ADDENDUM # 001

ST. CLAIR CATHOLIC DISTRICT SCHOOL BOARD
ST. JOHN FISHER CATHOLIC SCHOOL

TENDER NO.: 632-CP1505

Issue Date:
Wednesday May 13, 2015

A000 –COVER SHEET

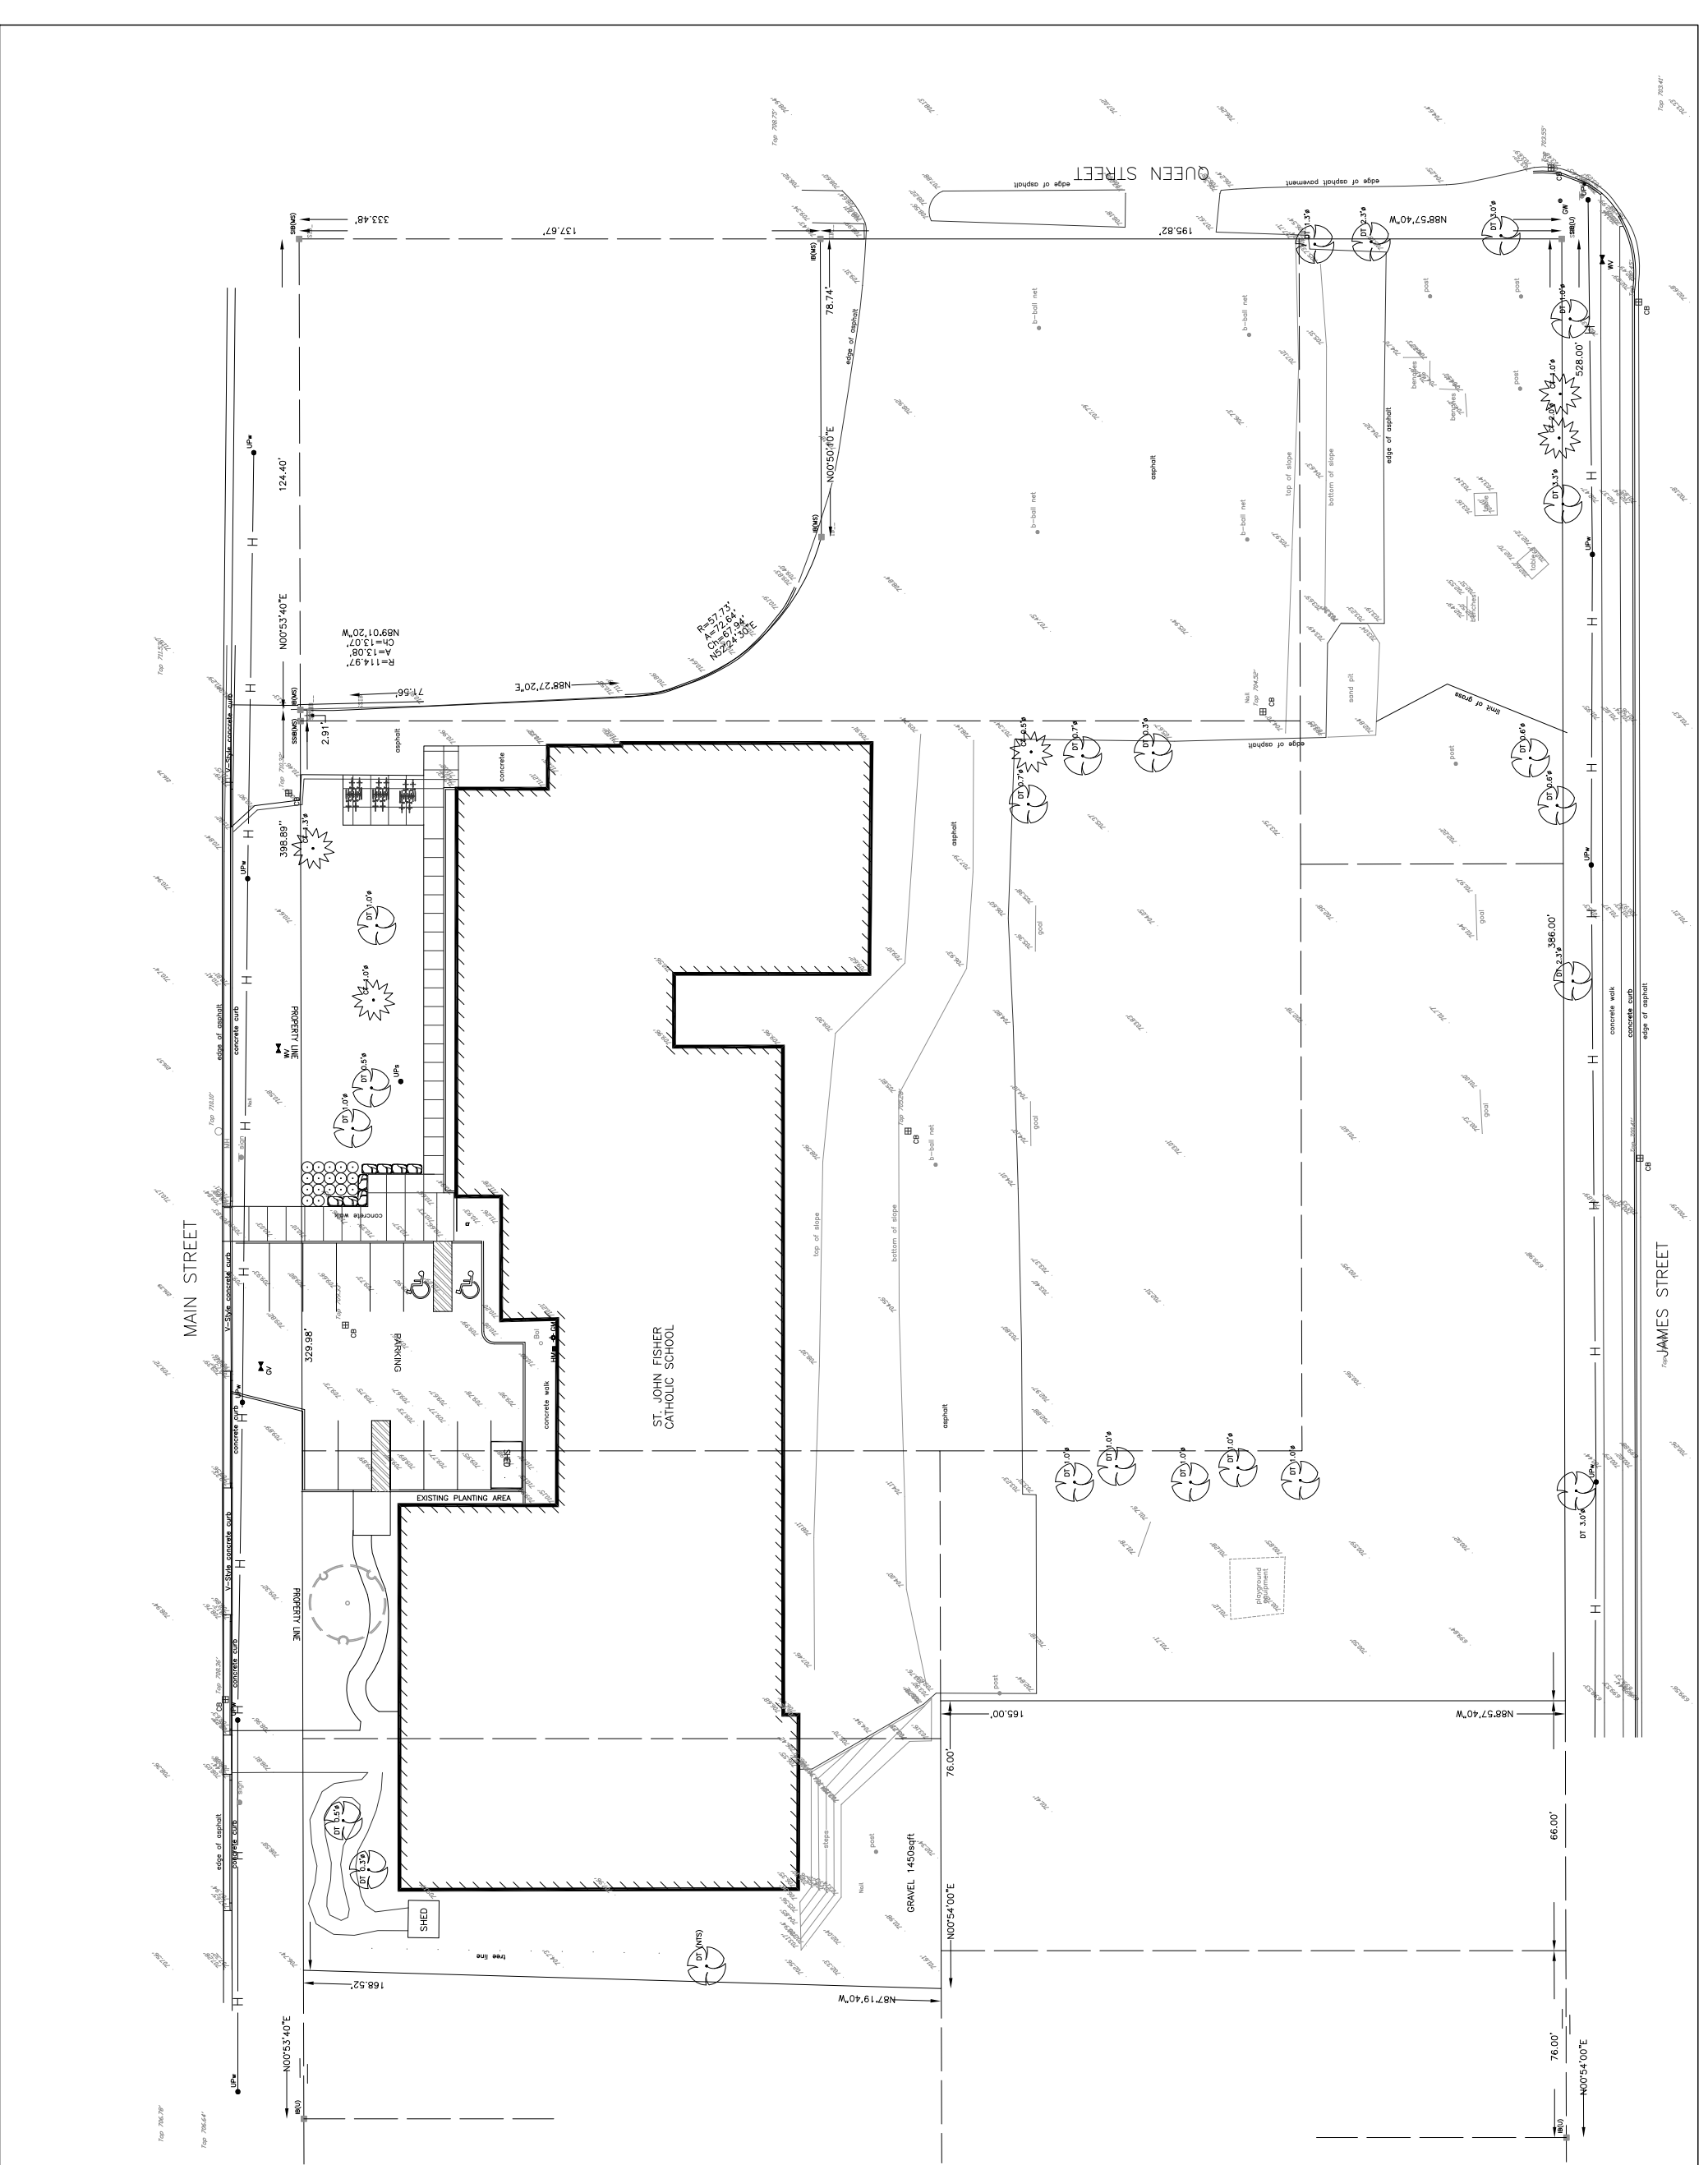
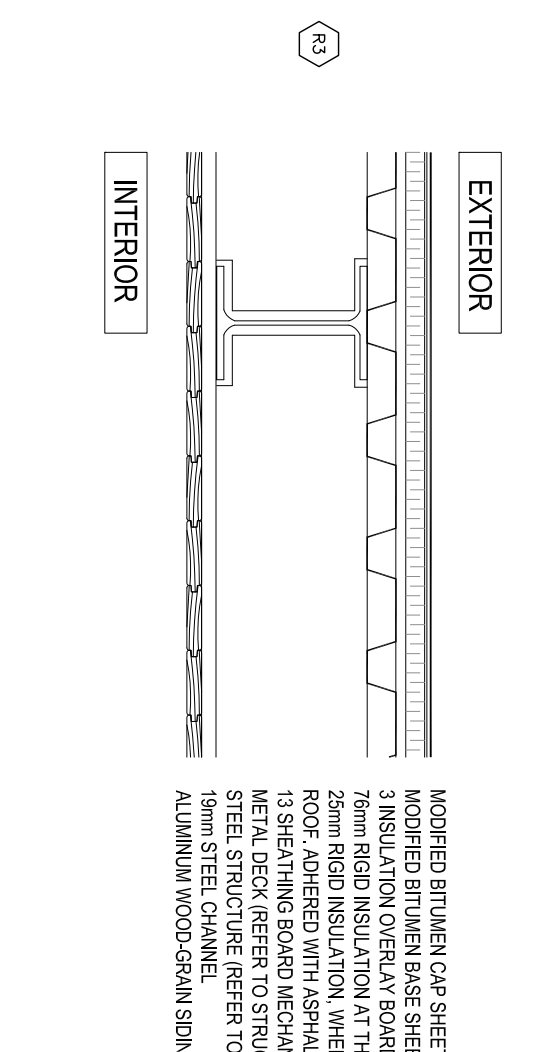
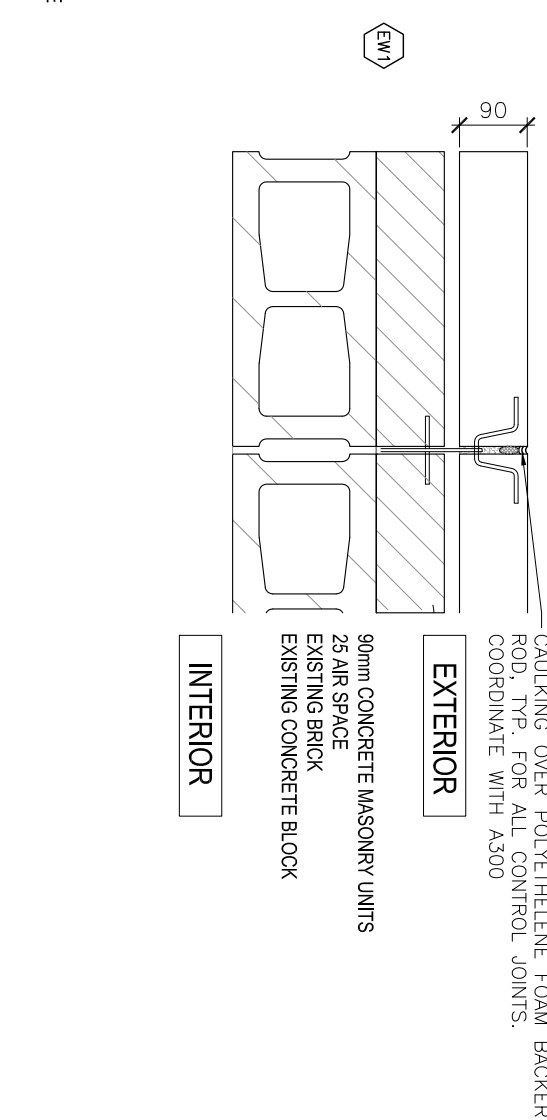
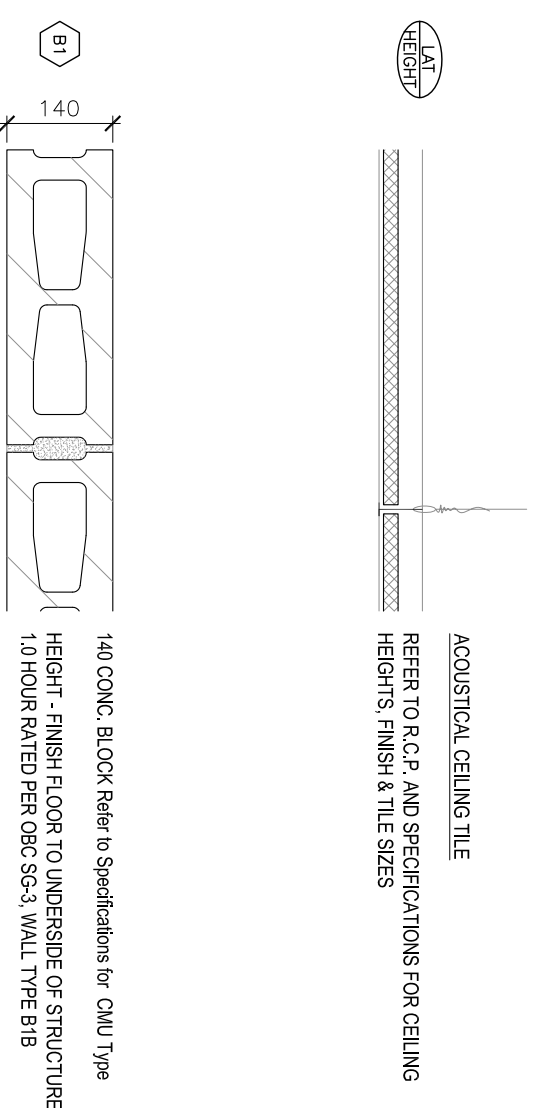
Refer to revision clouds and addendum 1 tags for changes to drawing.
